Comment (#167):

(TDL #385 D2.2)

Comment: Do we need the spec for Irms in 145.3.8.4?

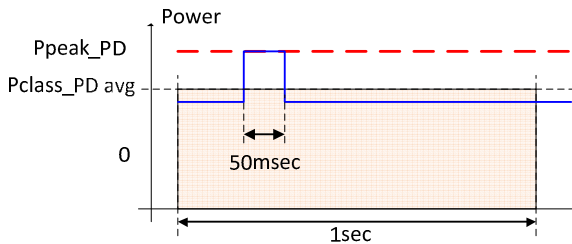
So if we agree that in our case, $P_{avg} = P_{rms} = V_{rms} * I_{rms}$

Then: $I_{rms} = P_{Class} / V_{port_PD-2P}$

The objective of this work is to get rid of the detailed RMS spec and to ensure that when input currents are measure at the PD, their maximum limits will be treated as RMS current and not Average current.

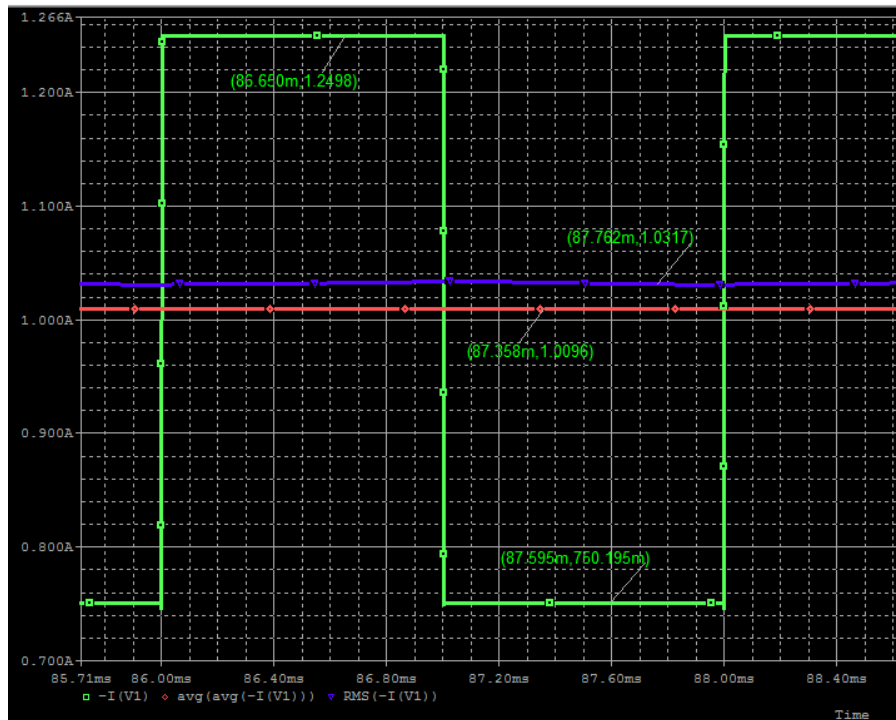
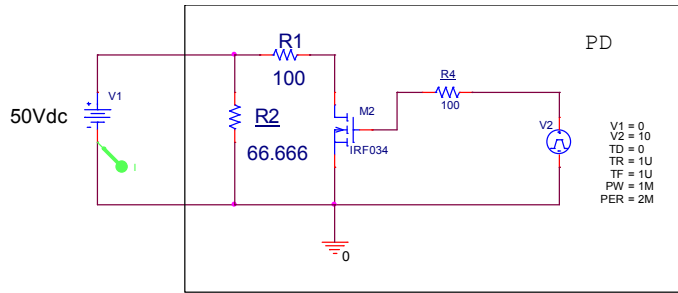
If we measure only the DC current when we test Icon or Icon-2P under overload conditions for compliance we will not know if PD is cheating or not.

PD can be designed to generate average current that will meet Pclass_PD/Vport_PD-2P value but the actual RMS current will be higher and will cause excessive power loss on PSE. See Annex B for examples.

In order to prevent excessive heat to PSE and PD components due to the fact that RMS value > AVG values, when we define limits for parameters that are current, we need to measure its RMS content and not their DC content.

The issue is lack of awareness that a DC current measurement is misleading.

The rule is: in a definition such $Icon = Pclass_PD / Vpd-2P$, Icon is the RMS value and not the average value for correct measurements and calculations.
